ADDENDUM NO.: 4

PROJECT NAME: **POLICE TRAINING ACADEMY HVAC COMPONENT REPLACEMENT**

DATE: 7/15/2013

CIMS PROJECT NO.: **35-06010**

2 **CHILLER CONTROL DIAGRAM**
NO SCALE

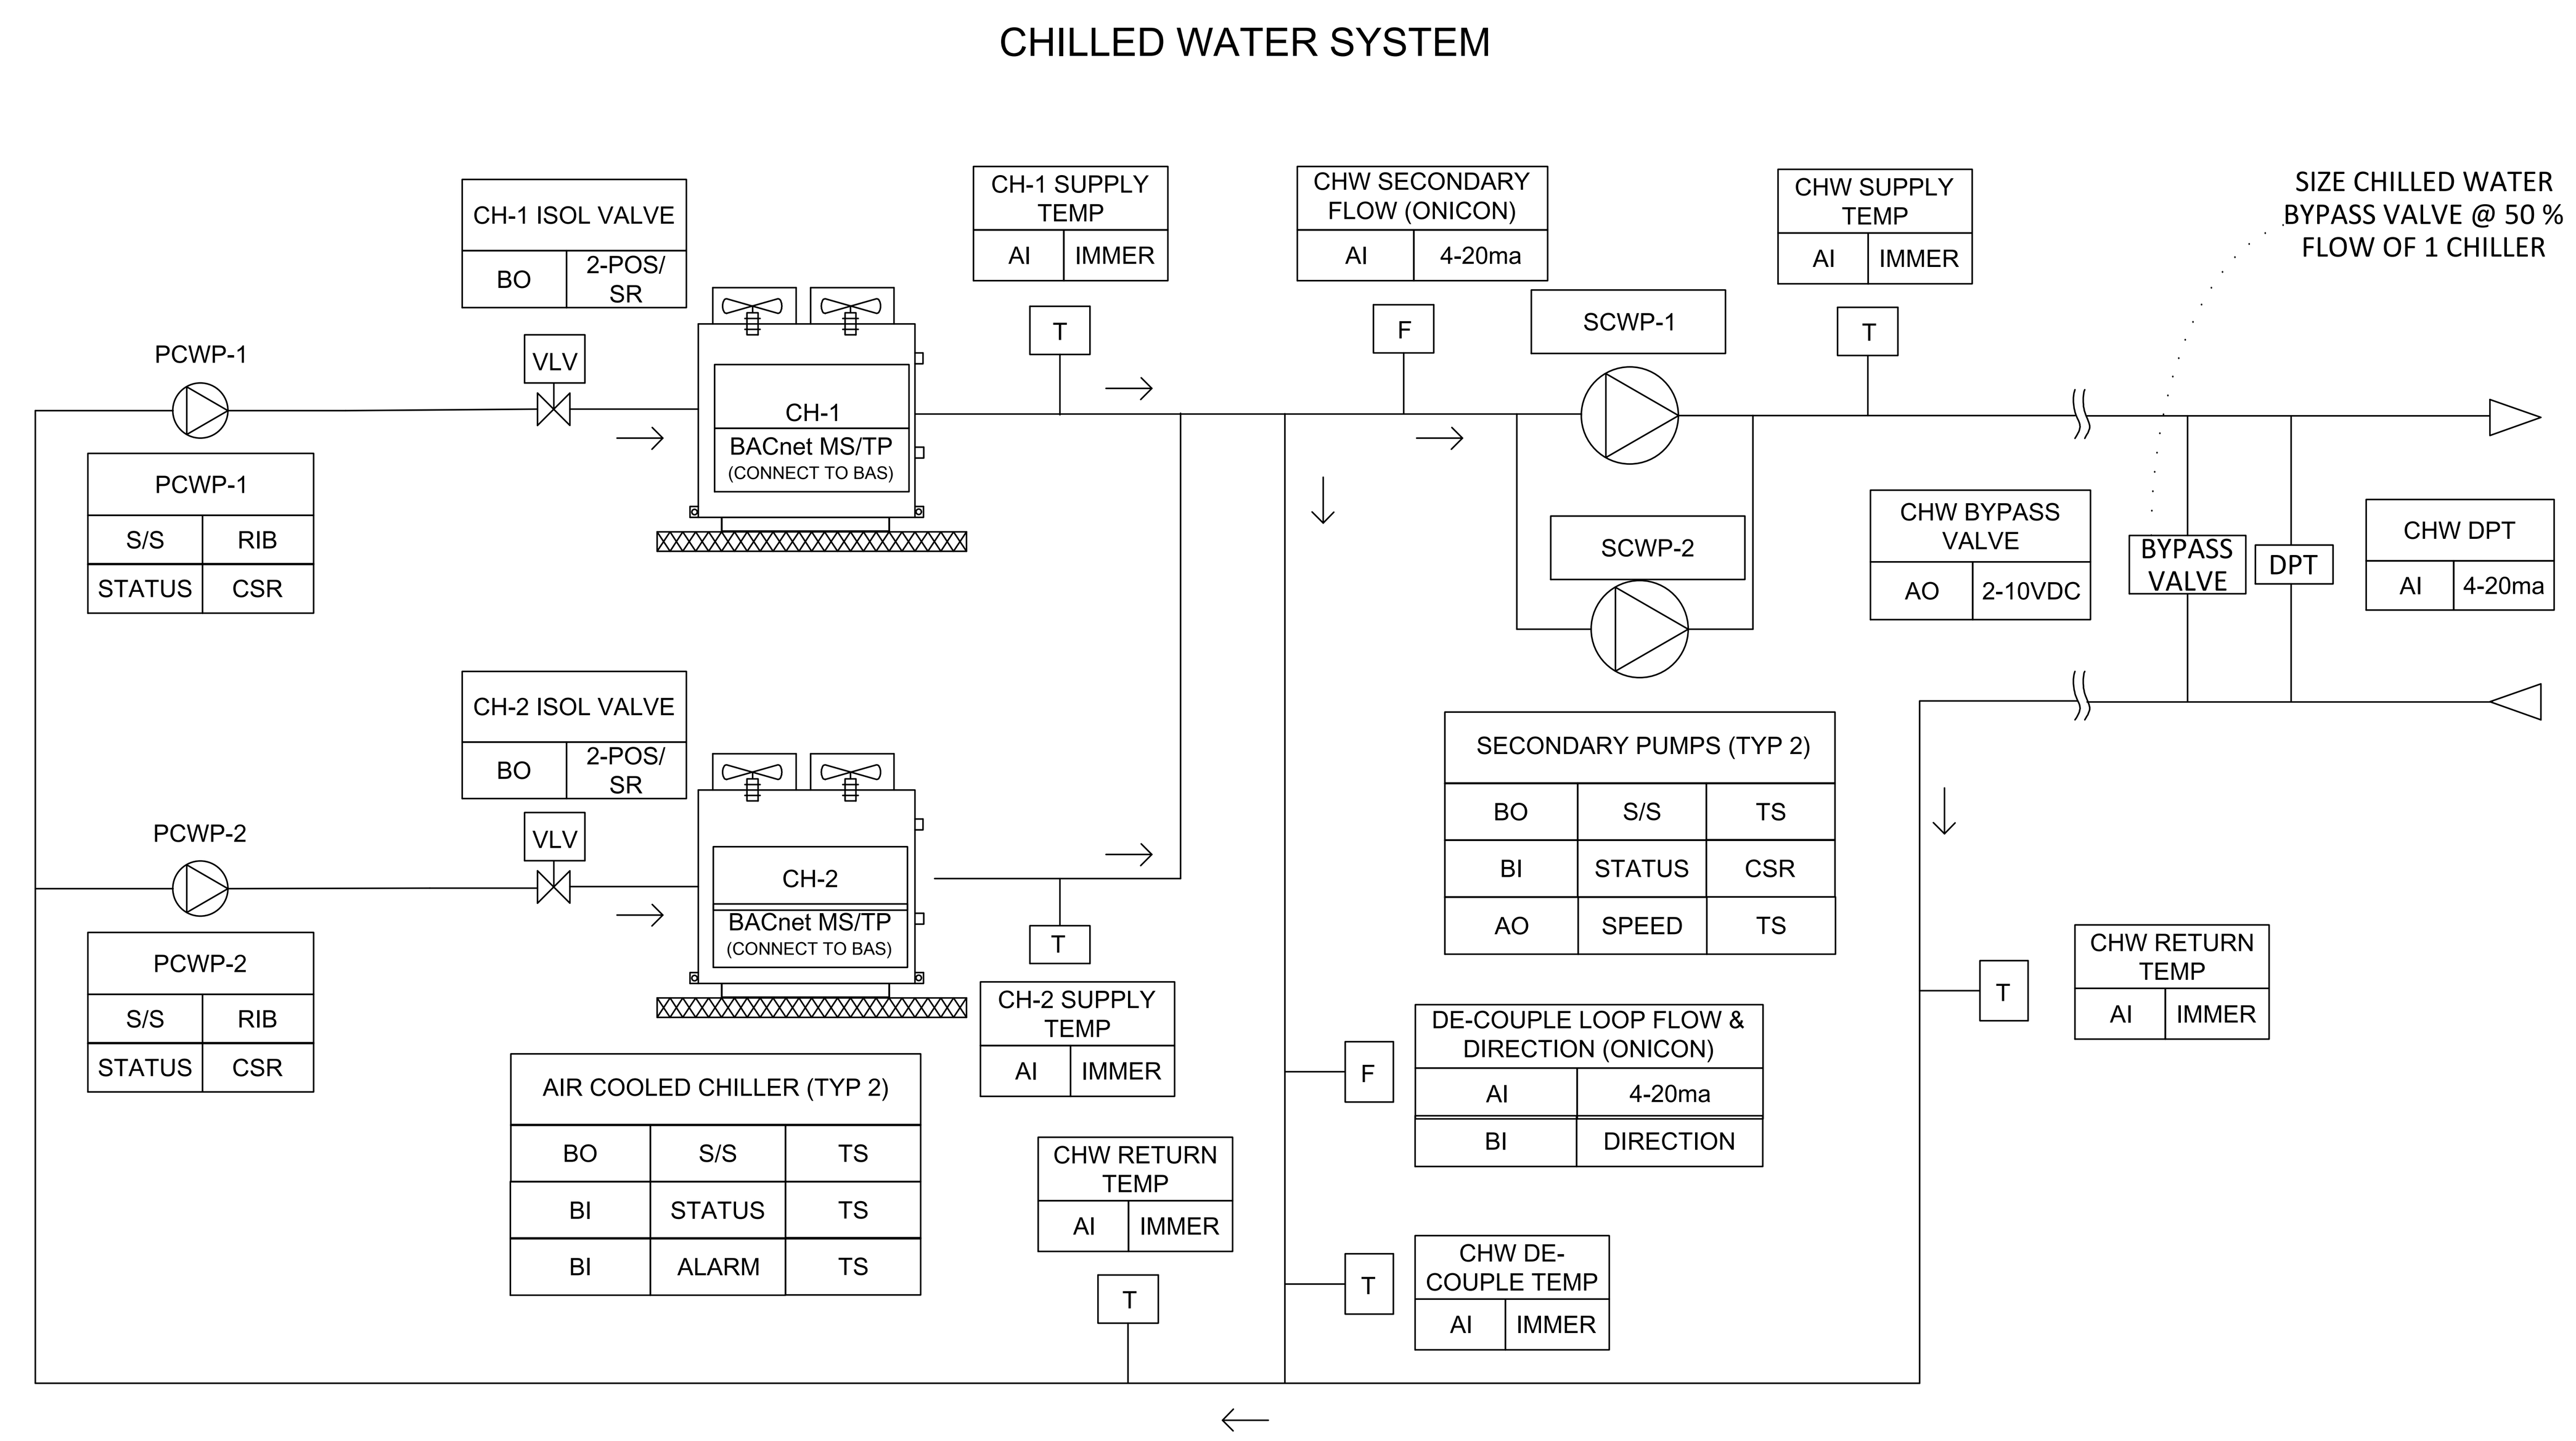
PLAN SHEET M5.2

- Revise Detail No.'s 1, 2 and 3.

2 SERIES COOLING-ONLY TERMINAL UNITS CONTROL DIAGRAM

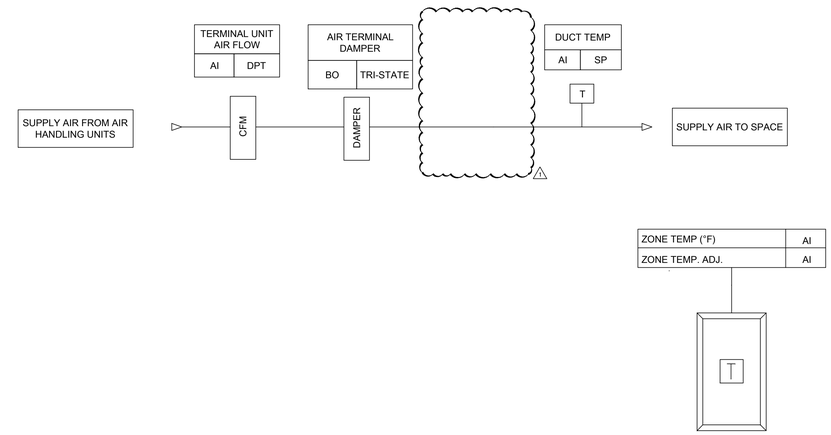
PLAN SHEET M5.4

- Revise Detail No. 2.
